LOCAL HISTORIC DISTRICT:	Wilmore
PROPERTY ADDRESS:	304 Westwood Avenue
SUMMARY OF REQUEST:	Addition
APPLICANT/OWNER:	John Dietrich and Beth Peterson

HDCADMRM 2019-00287 PID: 11908309 LOCAL HISTORIC DISTRICT: WILMORE PROPOSED PROJECT: ADDITION

November Meeting 2019

304 Westwood Avenue February 2019

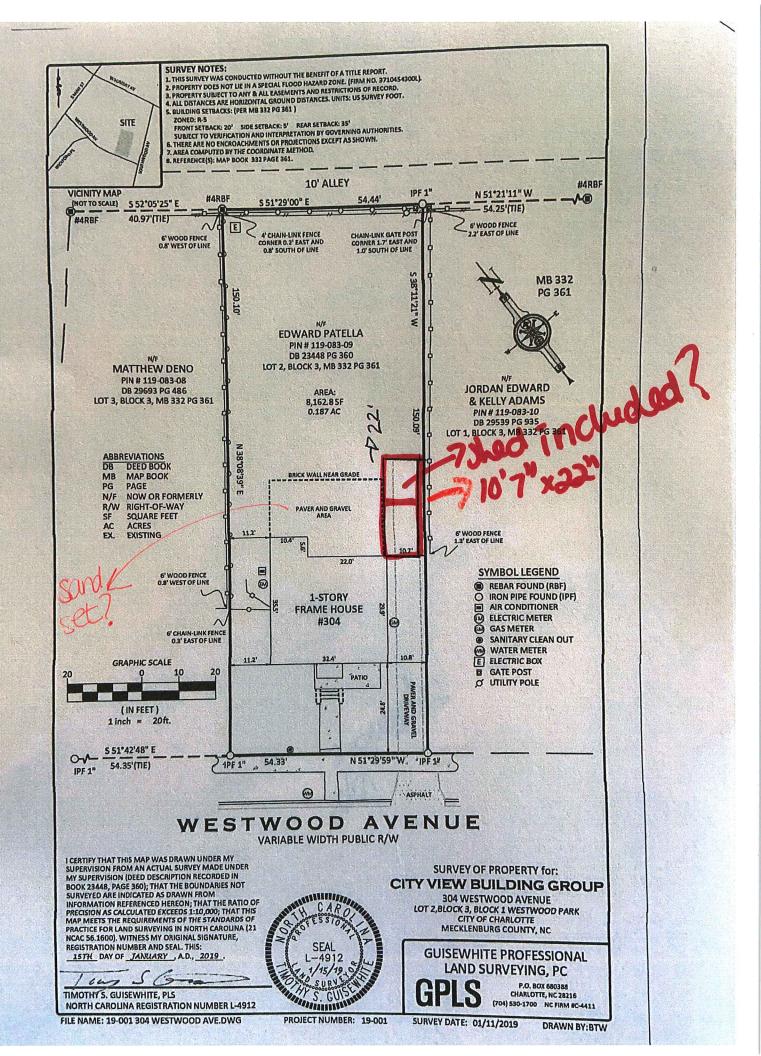
- 1. Brick tile installed over original concrete front porch floor.
- 2. Minor revisions may be reviewed by staff.
